Illinois Tollway Base Sheet Revisions
--

Section M		Base Sheet Drawings	
Drawing	Modification Summary	Effective: 03-01-2024	
Roadway Weather Information System (ITS)-Series 1300			
M-ITS-1300	RWIS Pole, Sensor Mounting Detail

RWIS POLE SENSOR MOUNTING DETAIL

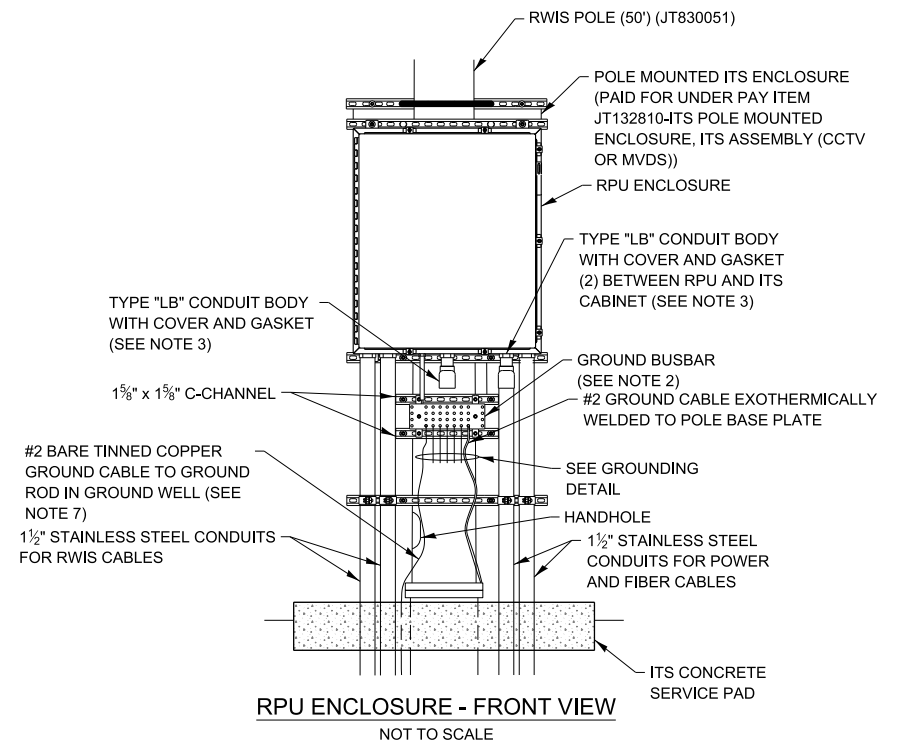
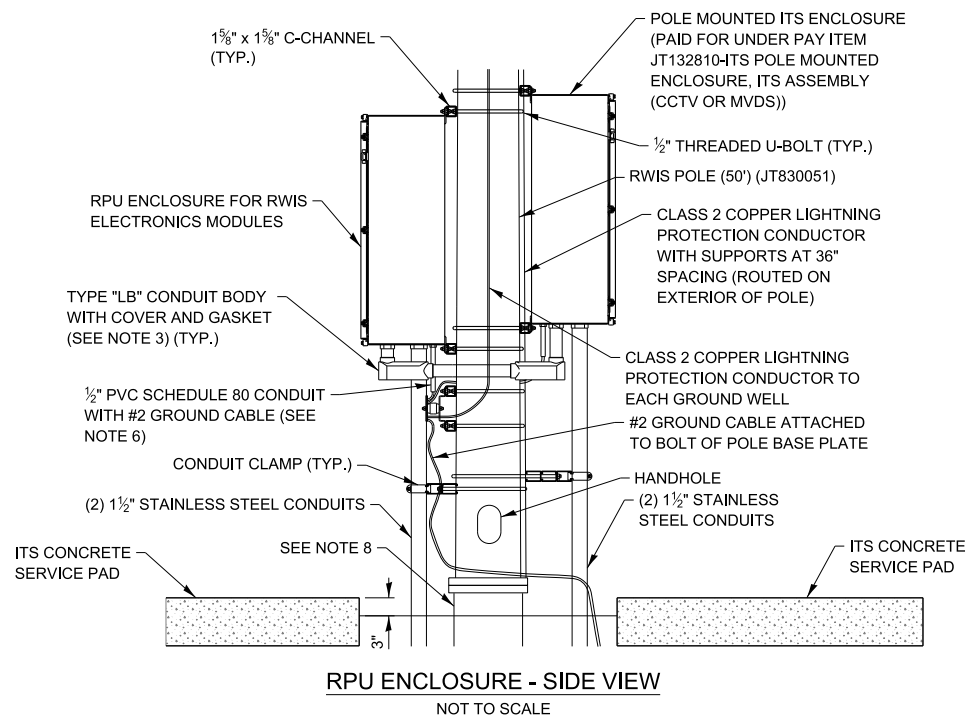
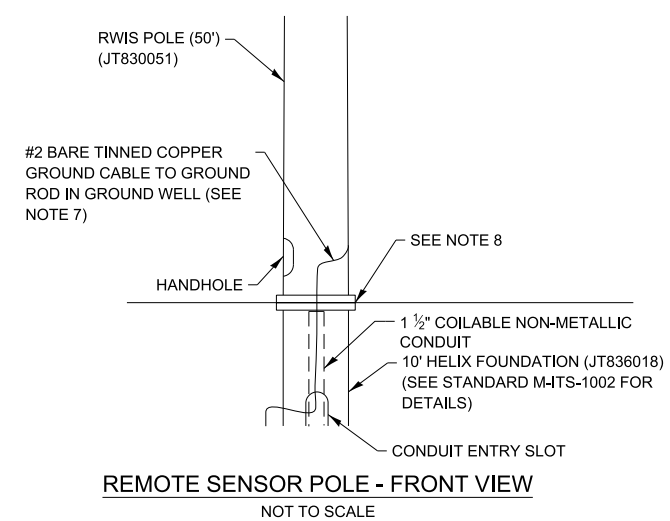
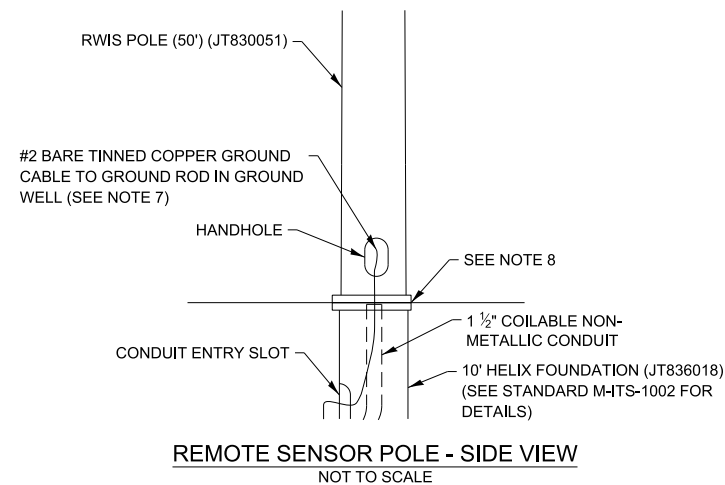
Sheet 1	Added a Note 10: Mounting height of the non intrusive temperature sensor on primary pole and on secondary pole is site specific and shall be per manufacturer installation manual.		
M-ITS-1301	RWIS Cabinet Wiring Diagram

8. WIND SENSOR CAN BE INSTALLED ON THE SECONDARY POLE IF PRIMARY POLE CLOSE TO TREE LINE.
 9. ALL CABLES INSTALLED IN A POLE SHALL USE A GROMMET.
 10. MOUNTING HEIGHT OF THE ROAD SURFACE TEMPERATURE SENSOR IS SITE SPECIFIC AND SHALL BE PER MANUFACTURER INSTALLATION MANUAL.

RWIS CABINET WIRING DIAGRAM

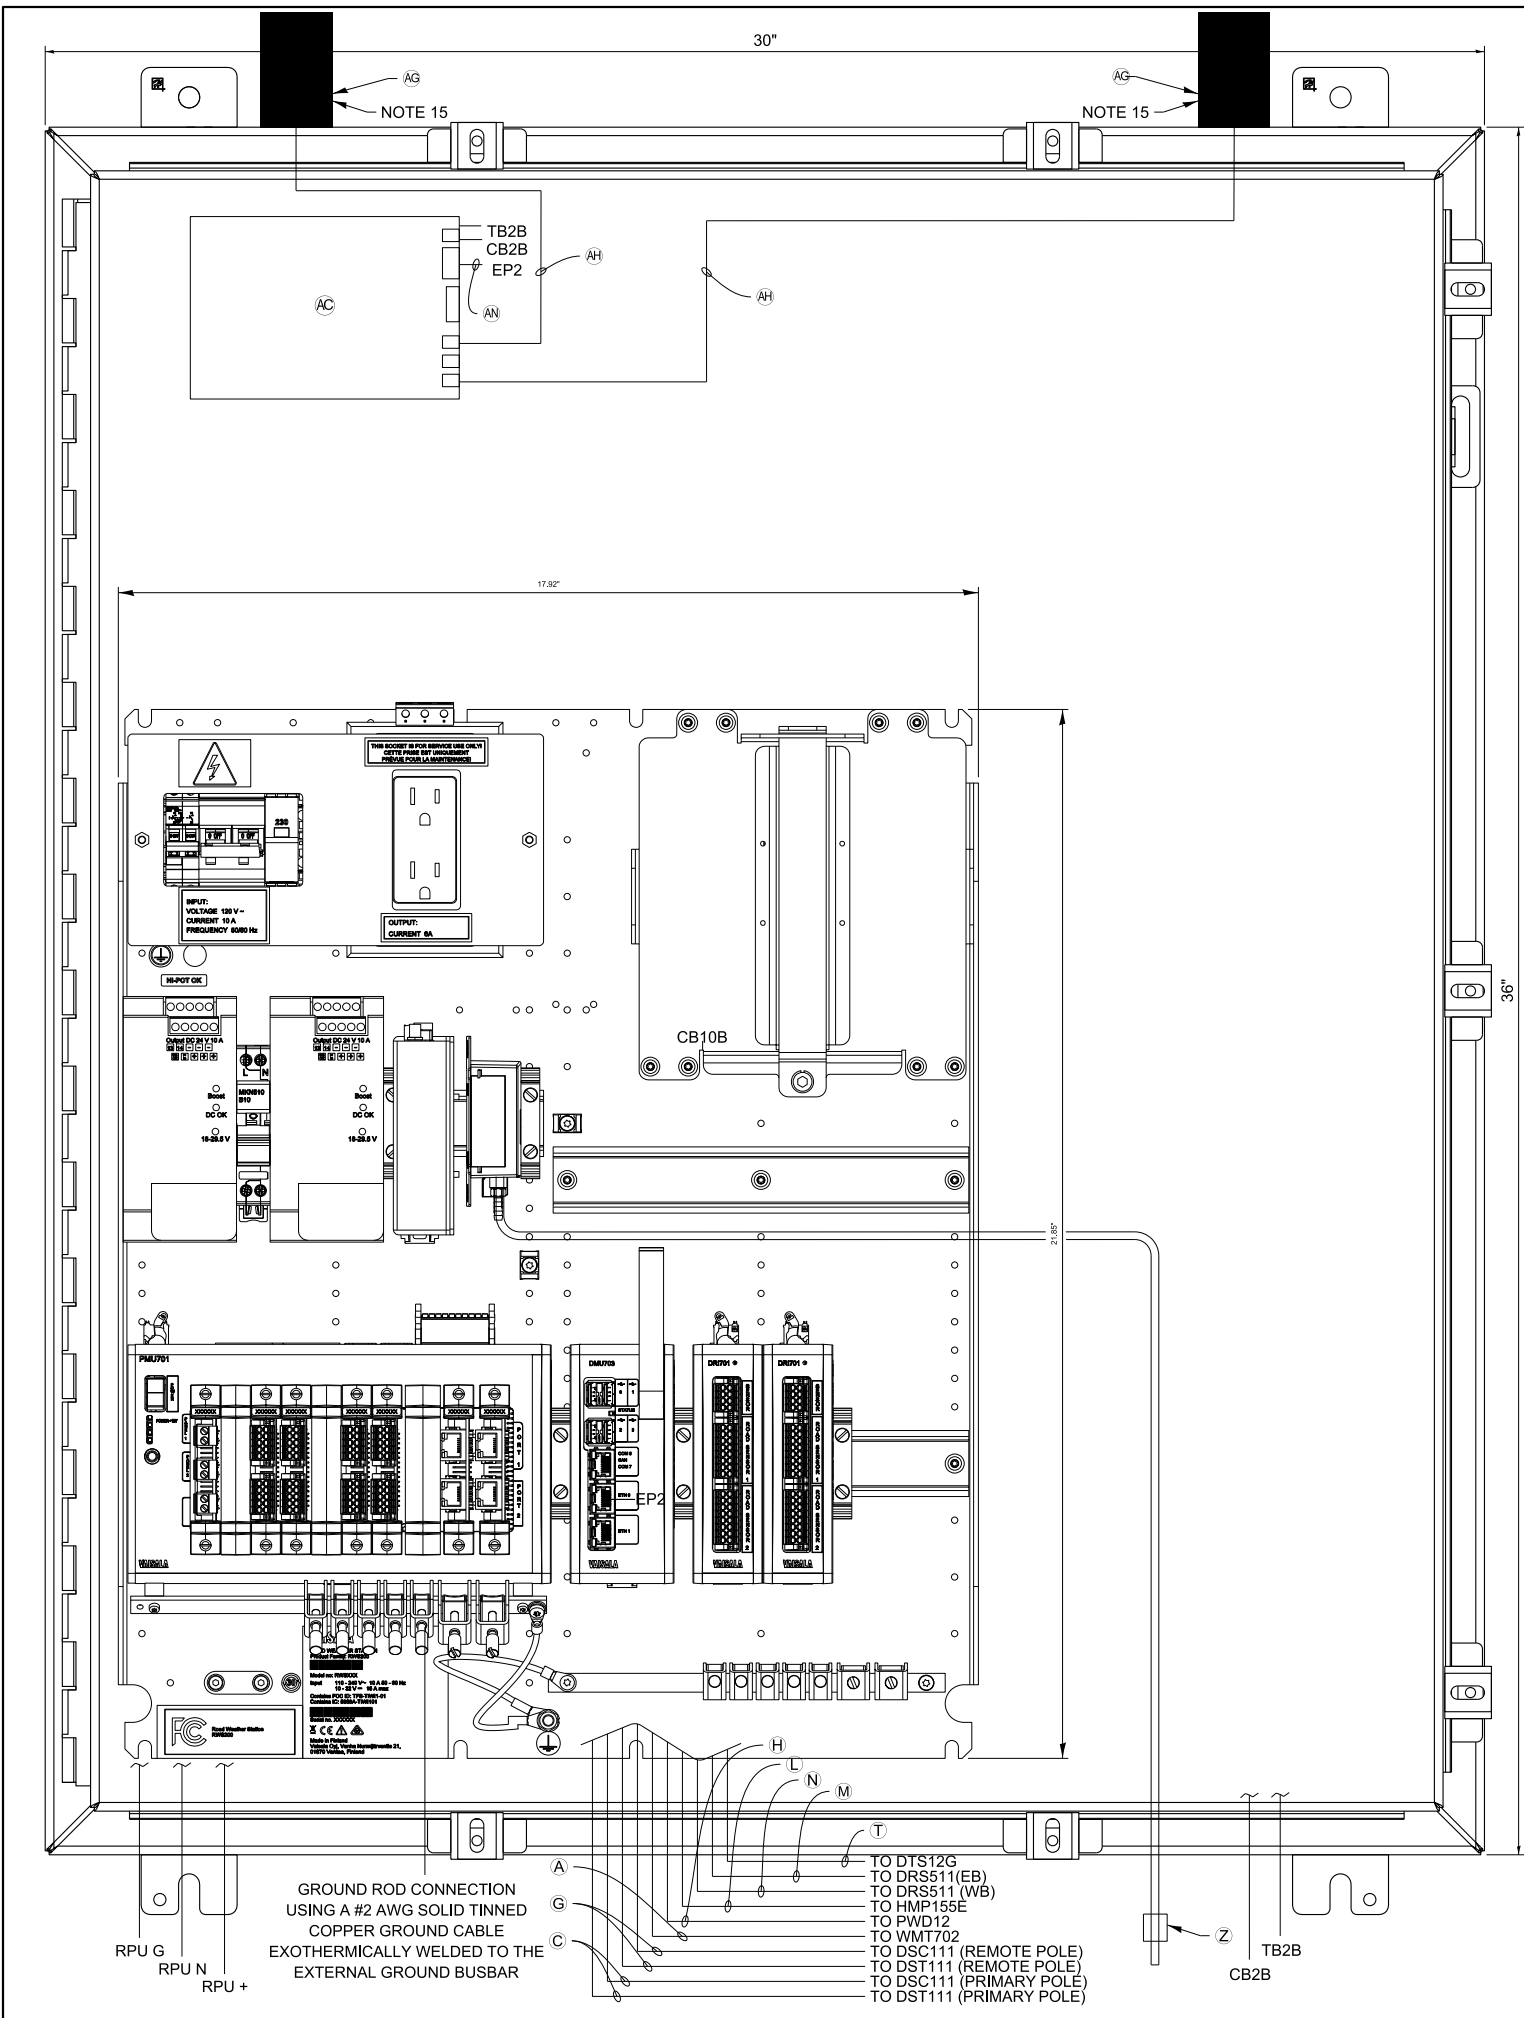
Sheet 1	Revised Note to Designer: If there is no CCTV in 400 feet from RWIS primary pole then install a CCTV and ITS enclosure.		
	Added CB10B and TB1B identification on breaker assembly		
	Relocated SFP 1 to port 1 and port 2 on the Gator Patch		
	Relocated SFP 2 to port 7 and to port 8 on the Gator Patch

IF THERE IS NO CCTV IN 400 FEET FROM RWIS PRIMARY POLE THEN INSTALL A CCTV AND ITS ENCLOSURE.
